Bearing temperature drift on the HX-400 pump series

Technical Note TN-2026-014 · Halvorsen Fluid Systems, Reliability Engineering

Document	TN-2026-014, revision A
Issued	12 March 2026
Author	Ingrid Moe, Reliability Engineering
Applies to	HX-400, HX-420 and HX-460 centrifugal pumps
Status	Released for field service

Figure 1: Drive-end bearing temperature of two HX-420 pumps on the same site, one with the shielded bearing BRG-6207-ZZ and one with the sealed bearing BRG-6207-2RS, over the first 4,000 operating hours.

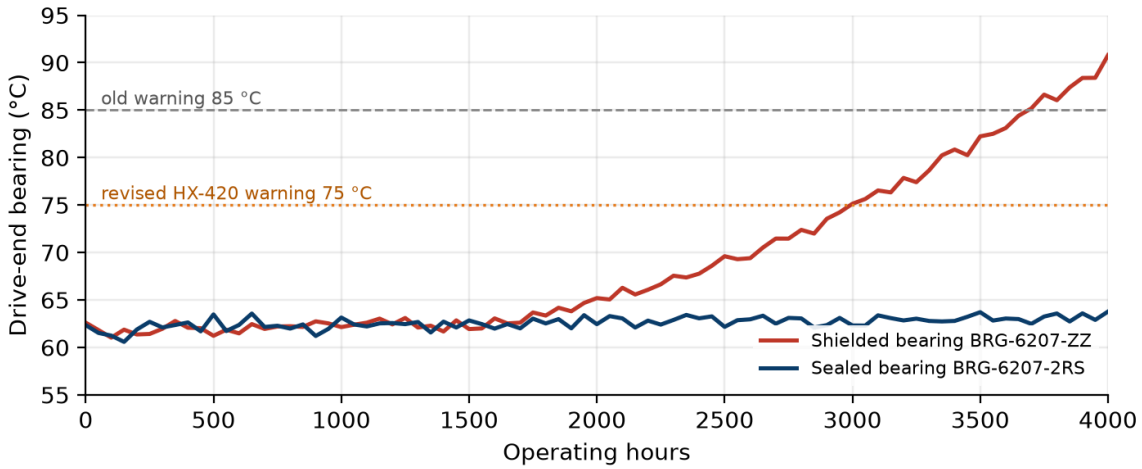
Figure 1 shows the pattern seen across the affected sites. Both pumps start at the same temperature. After about 1,500 hours the pump with the shielded bearing begins to drift upwards and crosses the old warning threshold shortly after 3,000 hours, while the pump with the sealed bearing stays within two degrees of its starting value.

The sealed bearing BRG-6207-2RS is now the standard drive-end bearing for the whole series. It has been fitted in production from serial number HX4-26-0410 onwards. Pumps below that serial number keep the shielded bearing BRG-6207-ZZ until their next bearing change, at which point the sealed bearing must be fitted instead. The two parts are dimensionally identical and no other component changes, so the replacement can be done during a routine service visit.
